**NSLPP MEETING HELD ON 6/10/21****Attachments:**

**ADDRESS/WARD:** 13 Shellcove Road, Kurraba Point**APPLICATION No:** DA33/21**PROPOSAL:** Alterations and additions to an existing dwelling house including excavation, two level addition below the existing dwelling, 15m pool, internal and external alterations to existing dwelling, landscaping works**PLANS REF:**

**OWNER & APPLICANT:** Mary Ann Beregi**AUTHOR:** Annelize Kaalsen of AK Planning**DATE OF REPORT:** 22 September 2021**DATE LODGED:** 2 February 2021**AMENDED:** 31 August 2021**RECOMMENDATION:** Deferred Commencement

Figure 3: Original Eastern Elevation

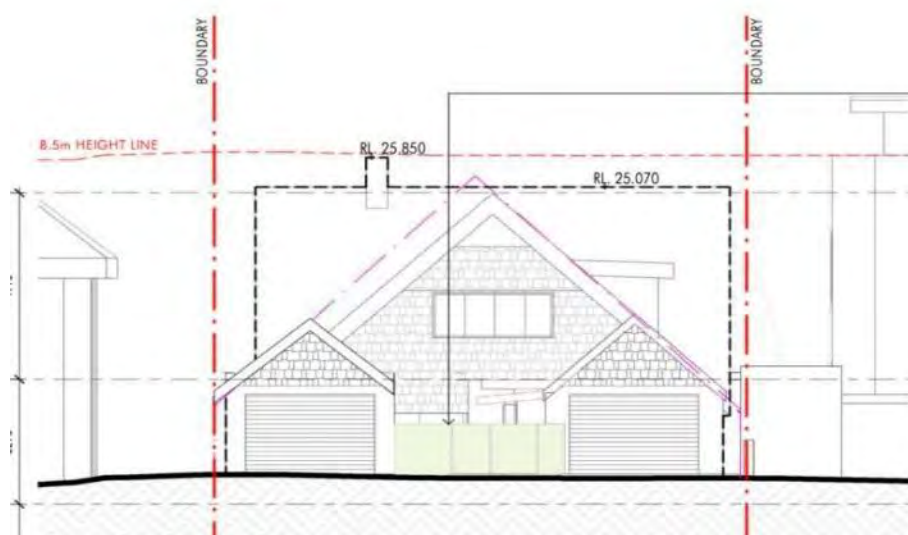
The amended plans have increased the width of the sandstone columns on the Lower Ground 1 level to 1m wide at each end whilst the sandstone columns in between have been reduced to 800mm. The sandstone columns on the Lower Ground 2 level have also been thickened to 1m wide however only at the northern end (no change to southern end) whilst the two sandstone columns in between have been widened to 800mm.

The amended plans seek to replace the original glass balustrades with steel balustrades on the eastern elevation, whilst the proposed glazing on the Lower Ground 1 and 2 levels were setback 300mm from the sandstone facade.

**Figure 10: Demolition / proposed excavation plan**

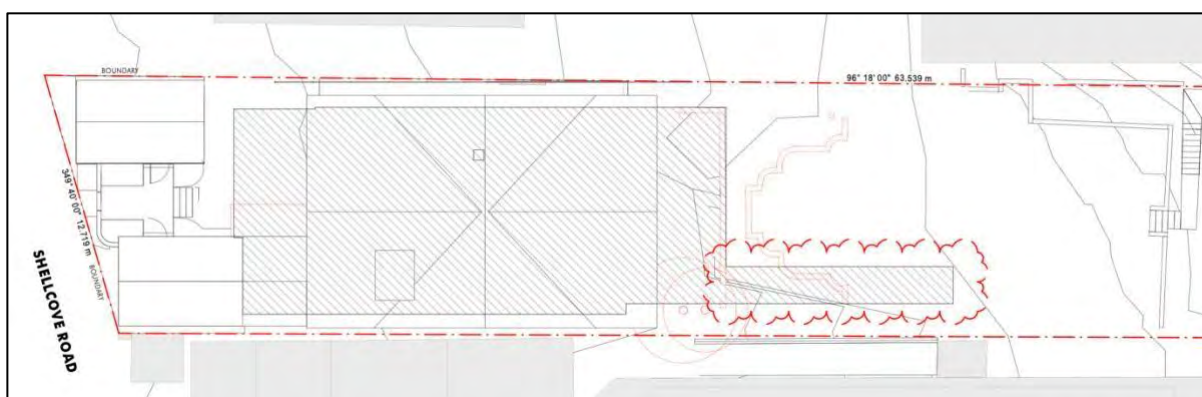
The amended development involves excavation to accommodate two (2) habitable levels under the existing dwelling (lower ground levels 1 & 2), as well as a new 15m lap pool (see **Figure 10** below).

The excavation under the proposed dwelling extends beyond the footprint of the existing heritage dwelling and is located in close proximity to No. 11 Shellcove Roads entry way (which is also heritage listed). The excavation proposed represent 31.7% of the site, to a maximum depth of 7.1m.

Title: **East & West Elevation**  
 Scale: As indicated  
 Sheet Size: A1  
 Date: 24.08.21  
 Number: 10506\_DA033  
 © copyright nettleton tribe partnership pty ltd

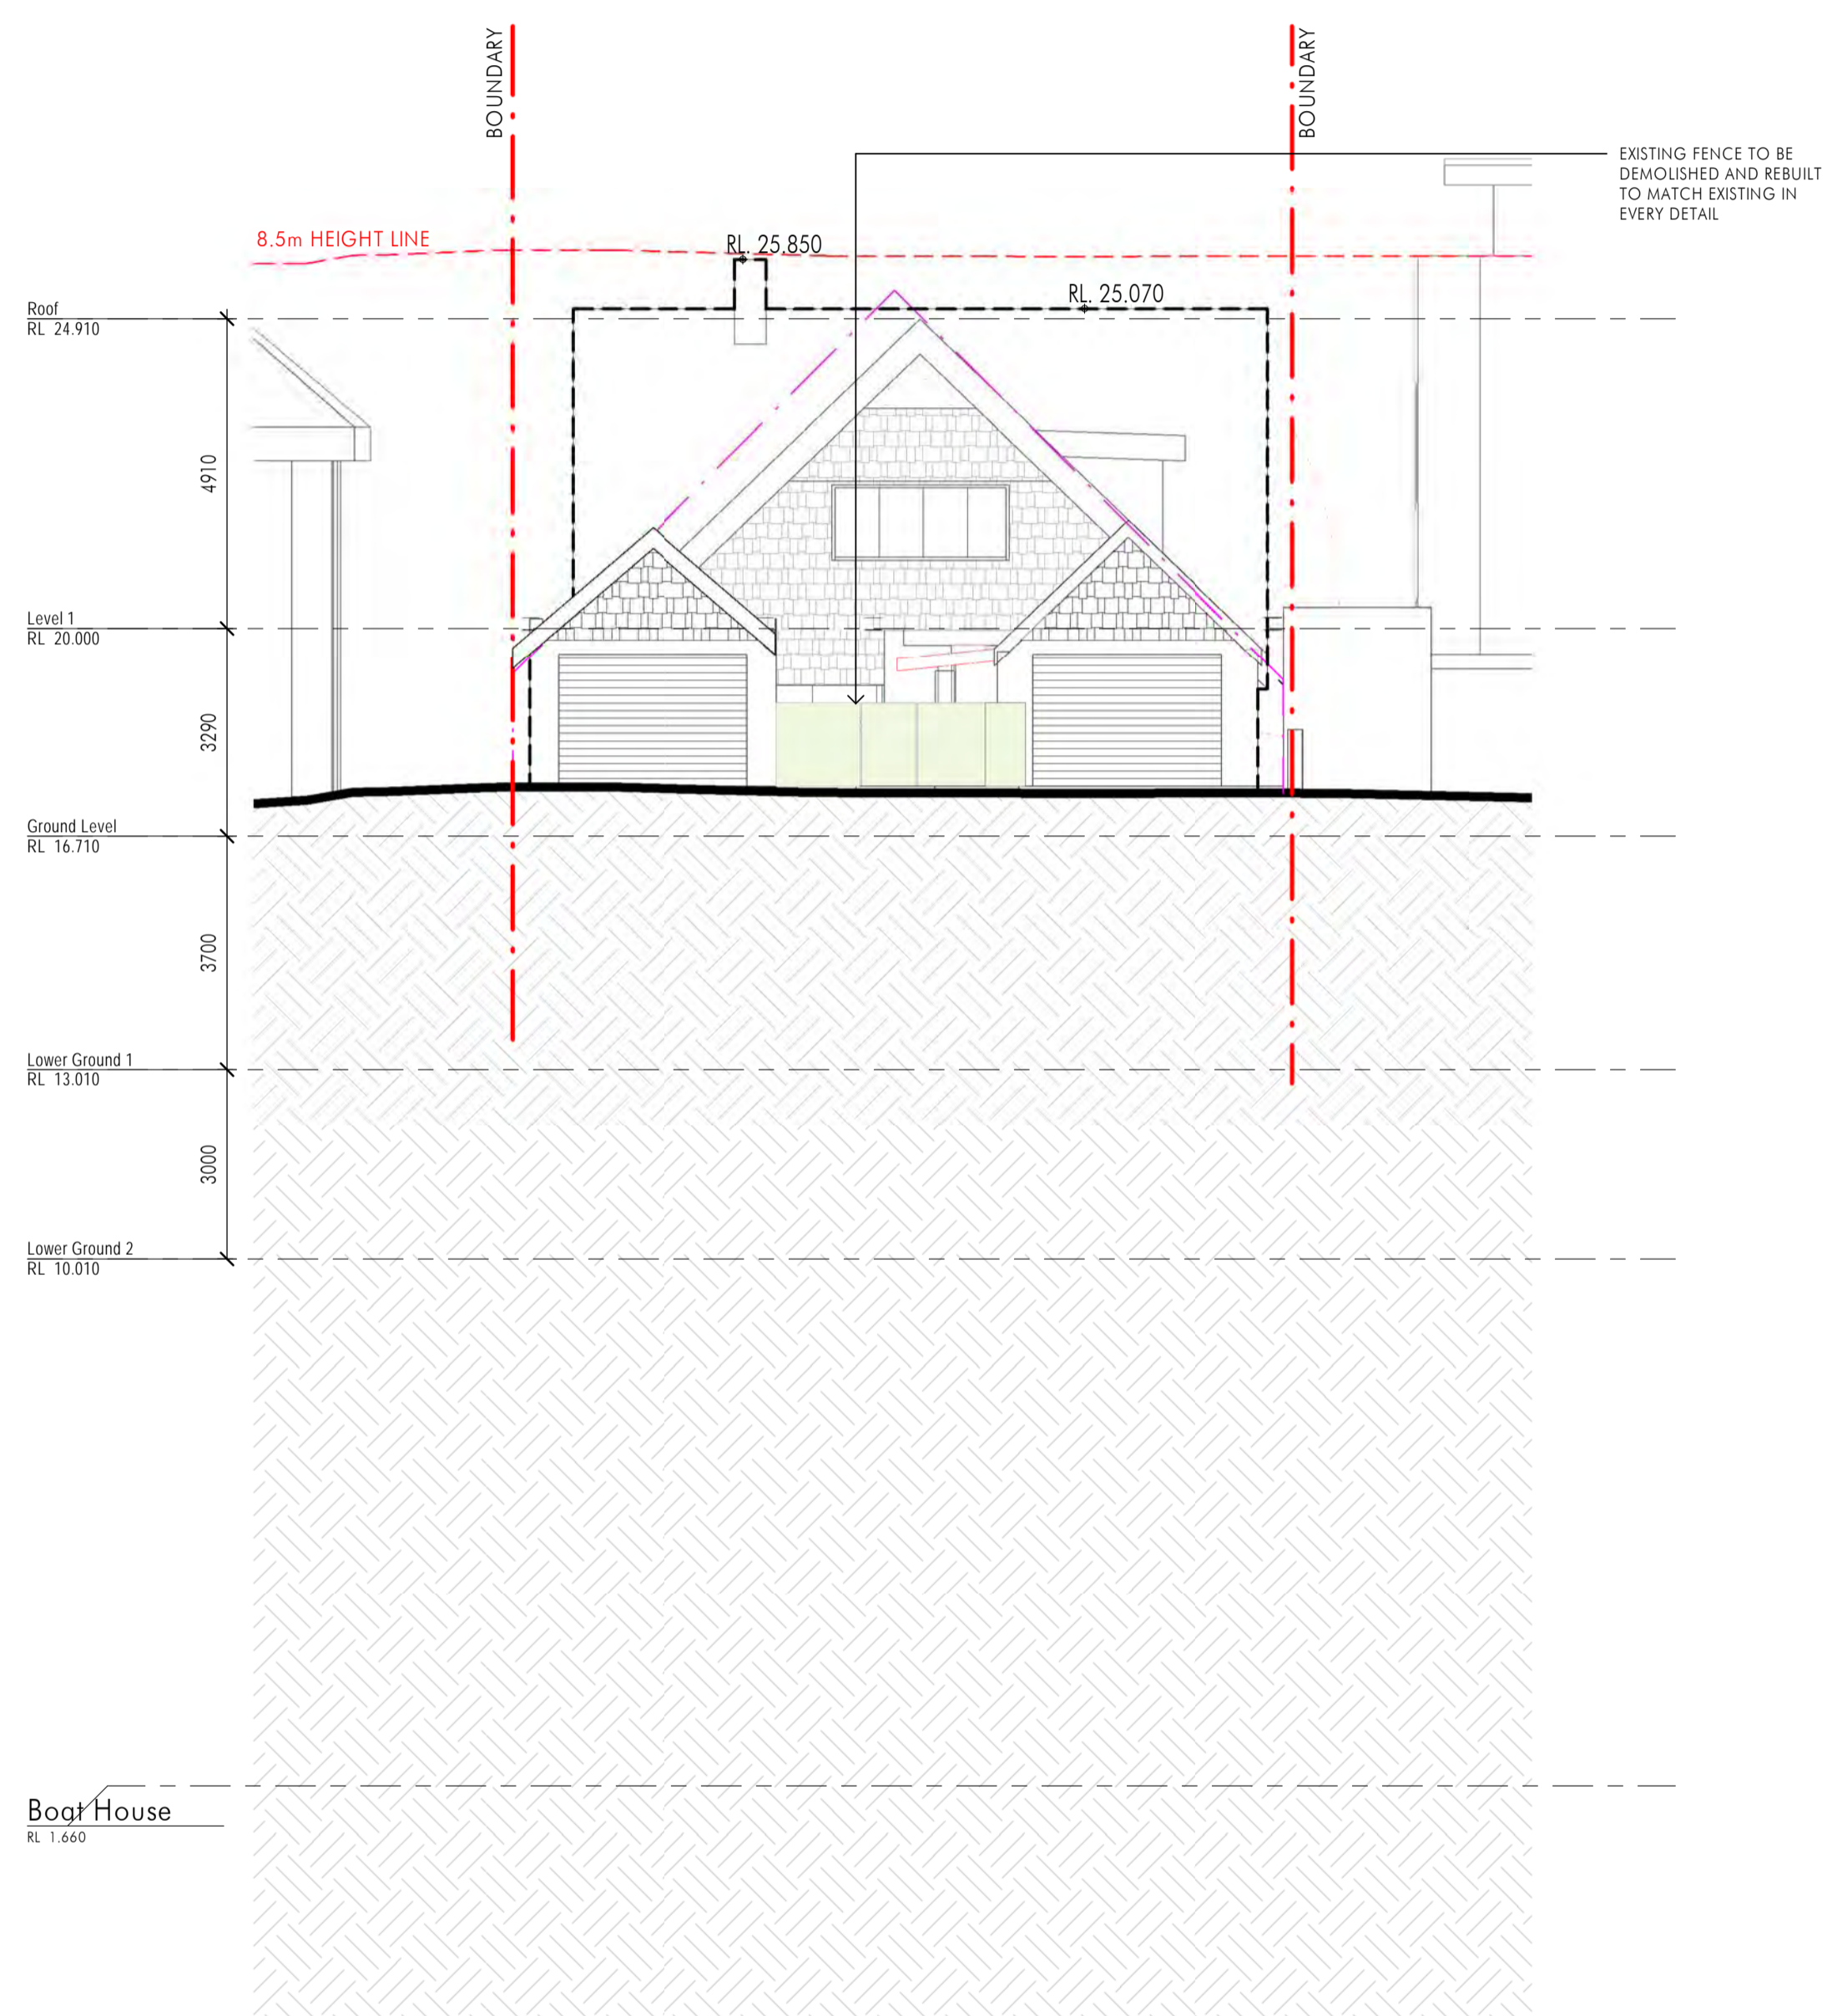
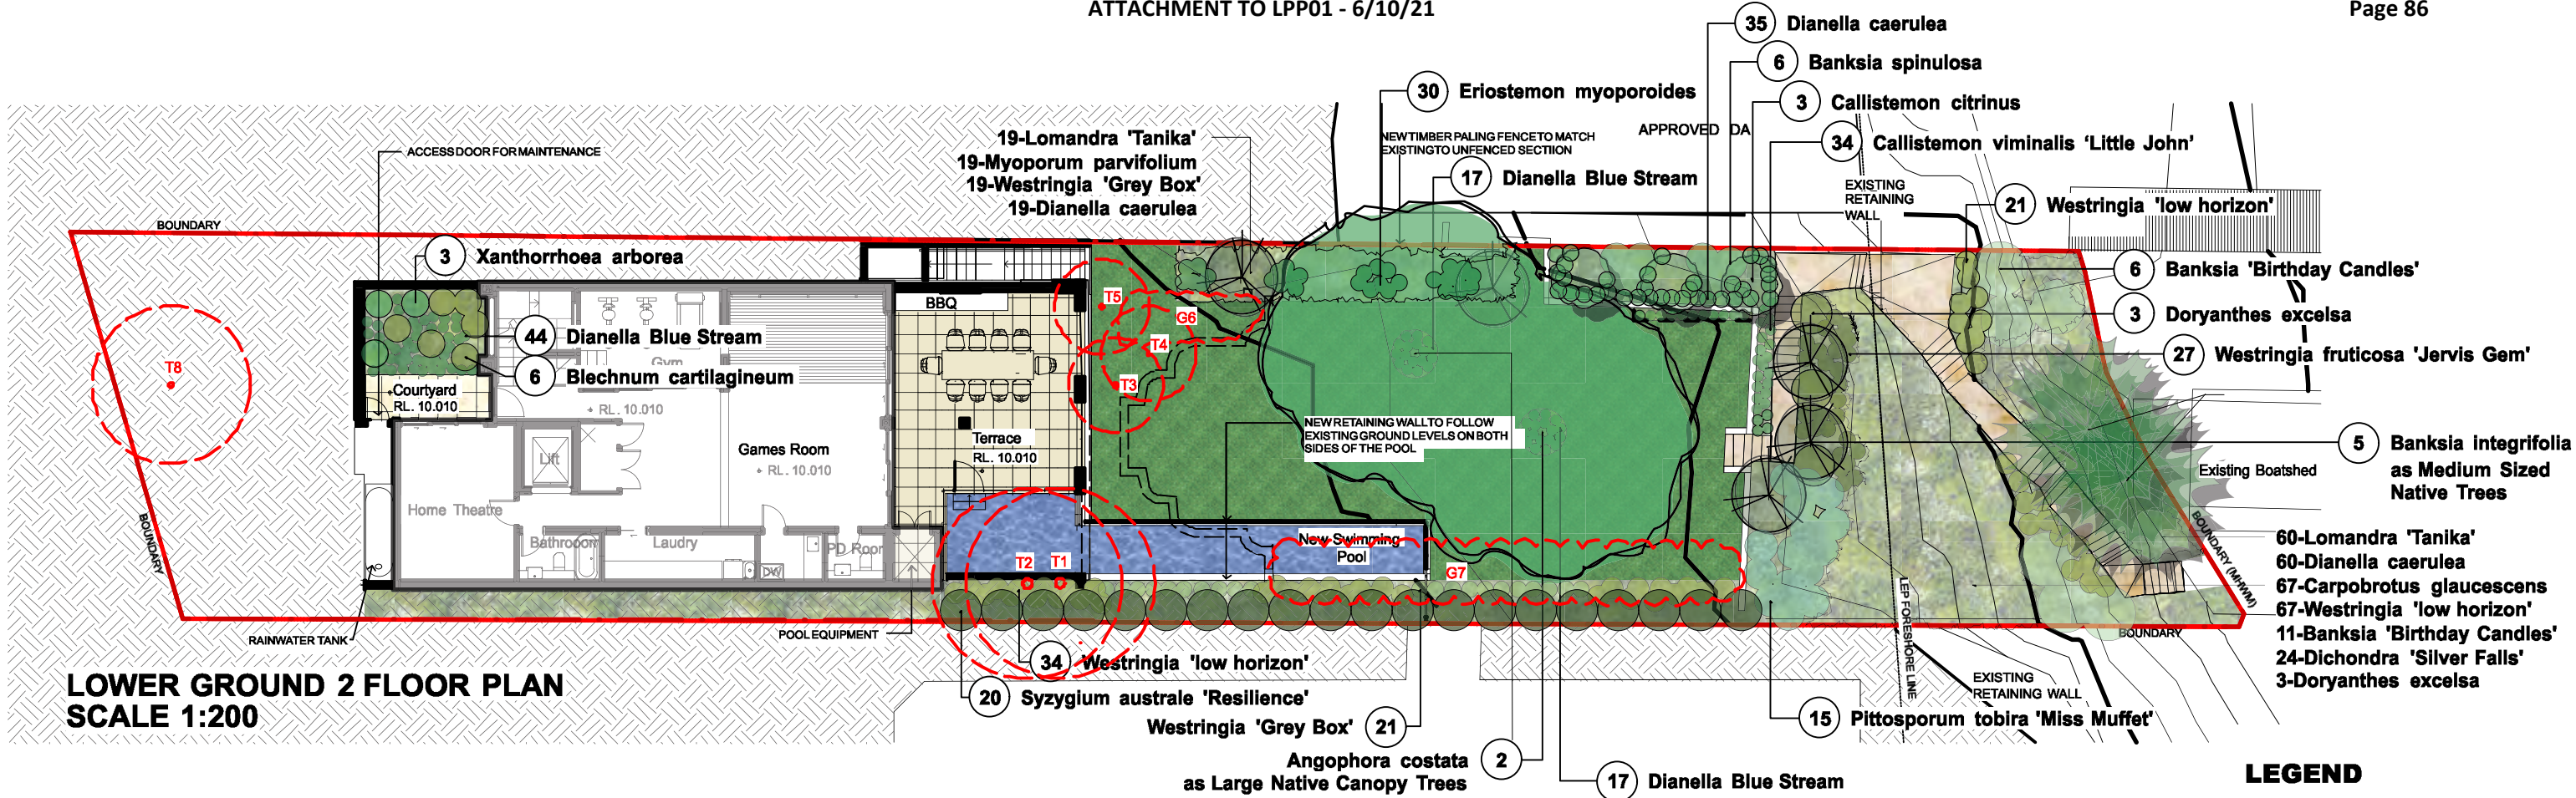
<p>The amended development application improves the visual character from that originally proposed, through the inclusion of greater use of sandstone proportionally to allow for thicker sandstone columns. However, the amended plans have not resolved to conceal the presentation of the Lower Ground 2 level as a visible level. A deferred commencement condition (refer to Condition AA1(a)) is recommended in order for the plans to be amended further so as to address the outstanding heritage requirements as well as the presentation of the lower ground 2 level.</p> <p>In addition, the proposed window proportions, the extent of the glazing as well as the material selection remains inappropriate and not in keeping with the style and built form character of the existing heritage listed arts and craft style dwelling. The heritage consultant recommended conditions of consent to address the extent of glazing and material selection (refer to Condition AA1(e and f)).</p>  <p>Figure 16: Non-complying height plane diagram – in this instance used to demonstrate massing</p> <p>The amended plans removed the ensuites from the existing rear verandah, however it fails to reinstate an open veranda by removing the existing unsympathetic glazing infill. The heritage consultant recommended a condition of consent for the glazing to be removed (refer to Condition AA1(c)).</p> <p>Note          The eastern elevation plan (DA033) is inconsistent with the existing situation.</p> <p>The architectural plans show the window to the master bedroom (Level 1) as 3 panels (annotated as existing timber framed windows). However, the existing opening accommodates 5 casement windows.</p> <p>No approval is given or implied in this consent for the alterations to existing window or door openings, not covered by this consent (refer to Condition A4).</p>

- b) Show reinstatement of the eastern ground floor verandah/balcony to an open verandah through removal of late 20<sup>th</sup> century glazing;*
  - c) Redesign the eastern elevation of the basement levels to continue the engaged columns to the existing eastern façade down to the new ground level and arrange vertically proportioned timber-framed windows/doors around these engaged columns, sympathetic to the heritage listed house, and respond adequately to the August NSLPP decision.*

- d) Show all new windows/doors to eastern and northern elevations as timber framed and vertically proportioned.*
  - e) Include a Schedule of Conservation Works to the house which should include restoration work to the timber shingling*
